### Global MX-5 Cup Car Technical Service Bulletin #05-23-2018A

#### Optional: 2016 & 2017 Global MX-5 Update: Headlight leveling sensor

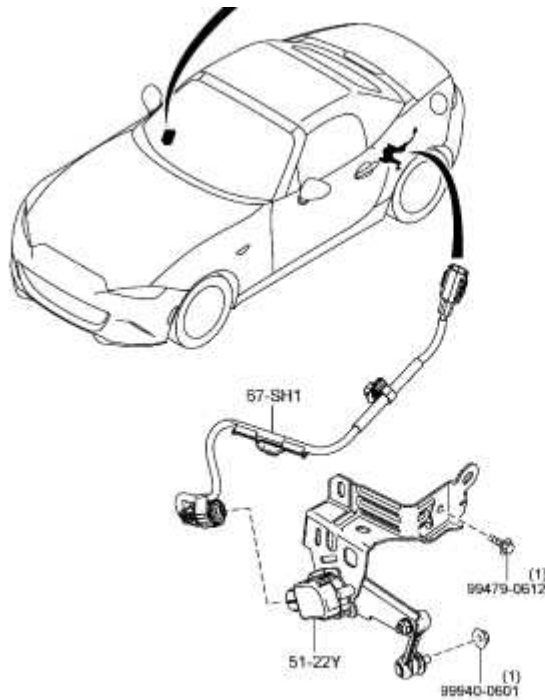
1. The headlight leveling sensor and sensor harness may be deleted.

1. On 2016 and 2017 chassis' is now permitted to remove the headlight leveling sensor (N243-51-22ZA or B) and harness (N243-67-SH0A) from the left rear lower control arm.
